91A1285

I wish to refer to your recent letter concerning an application for planning permission for the proposed extension and alterations consisting of (a) new restaurant/lounge, (b) new toilets, (c) conversion of stores to kitchen incorporating new pitched roof, (d) new fire escapes and fire doors (e) other ancillary space, (f) new signage at The Firhouse Inn, Firhouse Road, for Mr. H. Morton.

Report of the Dublin Planning Officer, dated 10th December 1991

This is an application for PERMISSION for extension and alterations consisting of (a) new restaurant/lounge, (b) new toilets, (c) conversion of stores to kitchen incorporating new pitched roof, (d) new fire escapes and fire doors, (e) other ancillary space, (f) new signage at The Firhouse Inn, Firhouse Road, for Mr. H. Morton.

ACCESS ROAD LAYOUT
AS ORIGINALLY DESIGNED

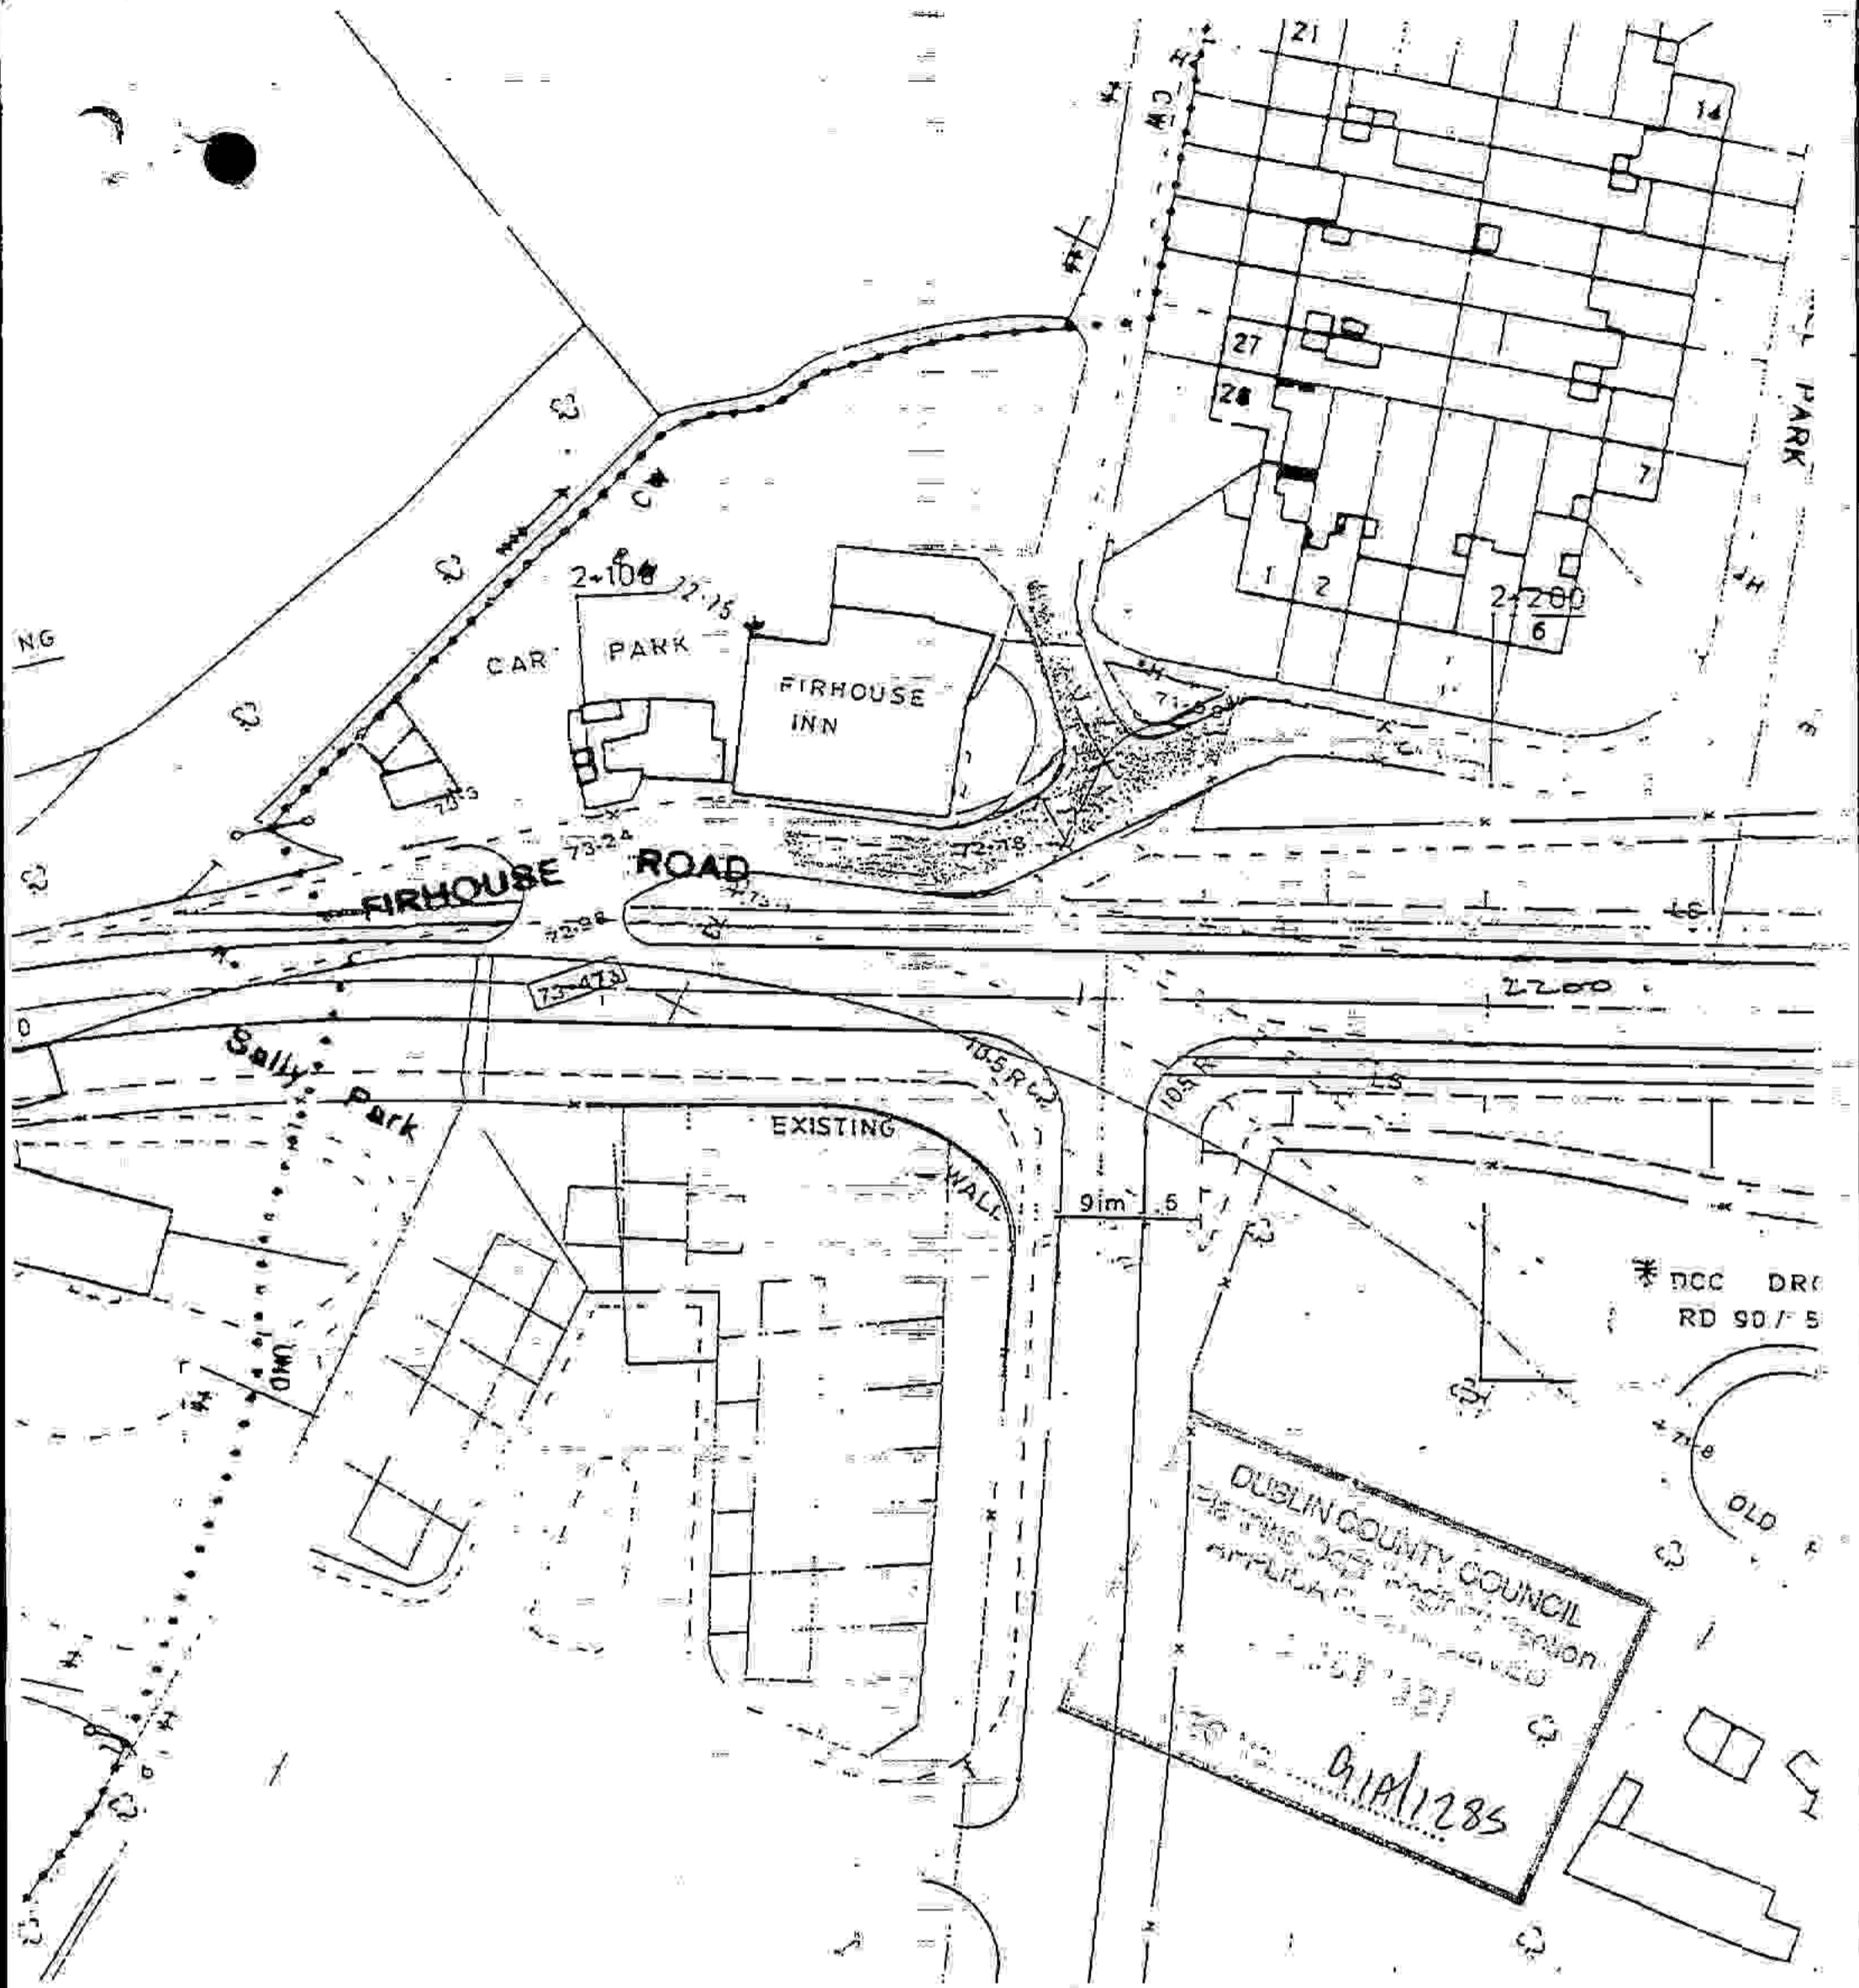
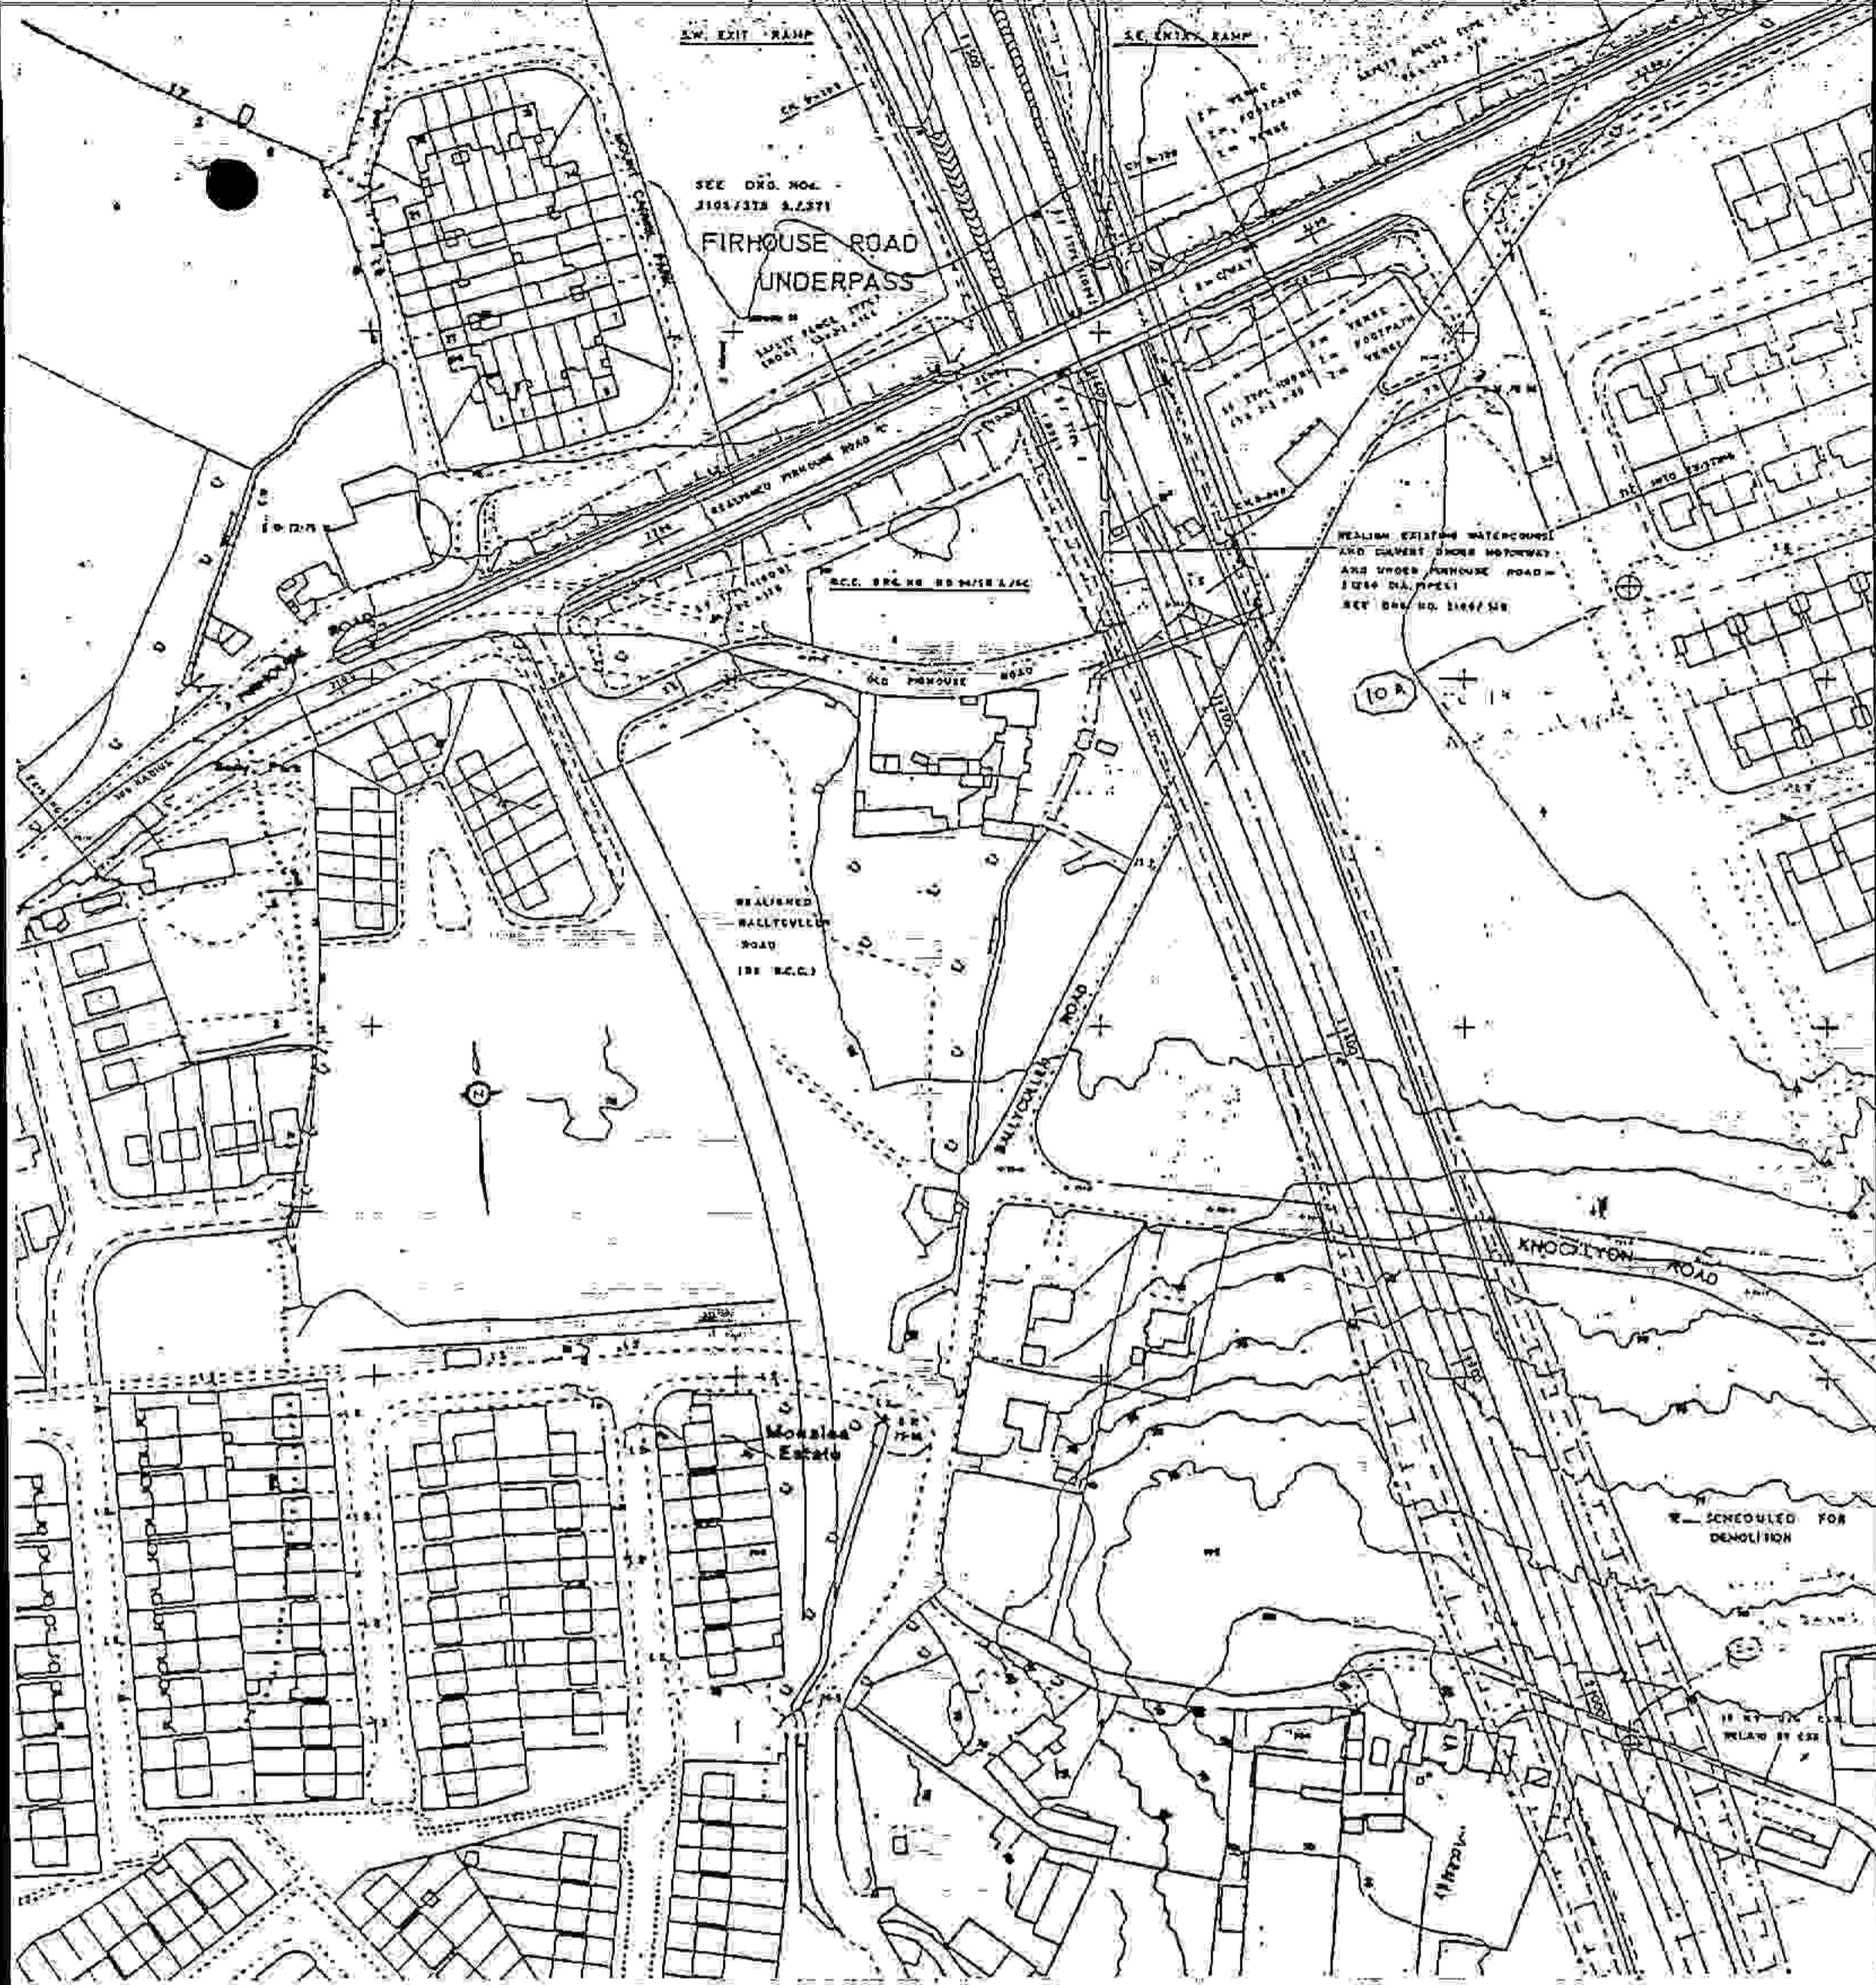
By Unsolicited additional information dated 23rd October, 1991, total proposed is 90 but only 78 could realistically be achieved - this 78 figure includes 4 kerbside spaces in front of the Firhouse Stores.

Allowing for dual use of parking spaces by the Firhouse Stores and Firhouse Inn still results in a shortage of 18 spaces (23%). I understand from the Road Engineers that they require egress at Mount Carmel Park partly to facilitate circulation, but also to allow cars to park in this area when the car park is full. As there is already a problem of cars from the Firhouse Inn parking on public open space and conflicting with the residential amenity of these cottages, this is unacceptable from a planning viewpoint.

- 1.1 We have examined the Car Parking layout afresh and as can be seen from drawing N^o F14/29 we can now accommodate 90 cars without any supervised spaces, all within the cartilage of the site.
- 1.2 A detailed examination of the floor areas indicate that the total public area of the completed development would be 345 sq m. (see drawing N^o F14/30 enclosed). Table 3.14 of 1983 Development Plan calls for 2 cars per 8 sq m. The required number of cars therefore, is 87. It is worth noting that the 1991 Draft Development Plan lays down the same car parking standard for public houses as the 1983 Plan.
- 1.3 The adjoining building "The Firhouse Stores" consists of day time uses so that the car parking spaces required can overlap with those of the pub in accordance with paragraph 3.13.9 of the Development Plan.

- 2.2 Realistically on-street car parking will occur. The proposed access road may facilitate the creation of controlled on street car parking for 5 cars on lay-bys as shown on drawing N^o F14/29.
